Access Compliance Report

Public Rights-of-Way

(Pedestrian Signals)

Intersection ID: N/A	Main Street:	Cross Street: N/A	Location: N/A
ADA ID: CB841523F795	Signal Type: Two Push Buttons-APS	Overall Compliance: No	Severity Score: BTN 1:N/A BTN 2: N/A No BTN: N/A
Codes/Mitigation Info/Possible Solution		Field Measurements/Component Compliance

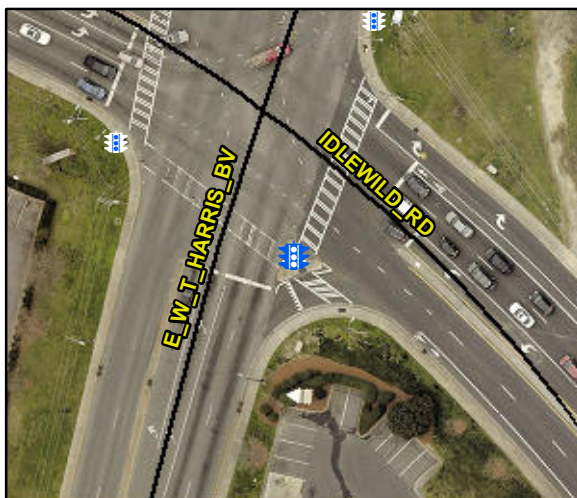
PROW/ADA: R209.1, TMUTCD 4e.08, R410.6,
R404.2, R404.3,

Possible Solutions: Remove & Replace
Replace APS Button With New APS Button.
Remove and Replace Clear Space.
